Company	Trenz Electronic GmbH
PCN Number	PCN-20251014
Title	TE0723-04 FTDI EEPROM Update
Subject	FTDI EEPROM
Issue Date	2025-10-20

Affected Product
TE0723-04-*

#1 FTDI EEPROM content: AMD-Licence key

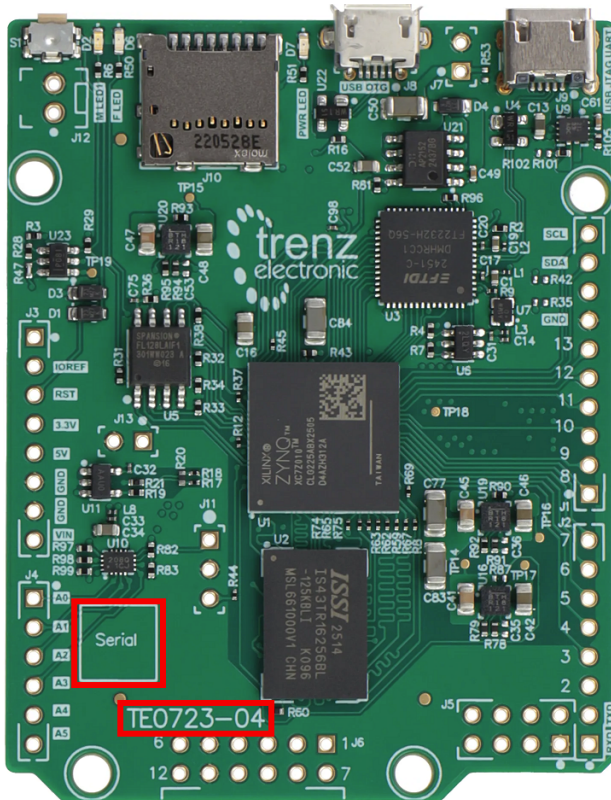
Type: Firmware change

Reason: Change according to FTDI programming method released by AMD with Tool Version 2022.2 and newer (UG980 - Chapter: Programming FTDI Devices for Vivado Hardware Manager Support).

Impact: AMD Licence key is compatible with AMD Tools greater and equal 2017.1 release. Programmer will be identified as 'Xilinx/TExxxxxxxxx' where the x is the serial number of the board filled with leading zeros, see [AMD FTDI JTAG Programmer#IdentificationofAMD/TrenzLicence](#)
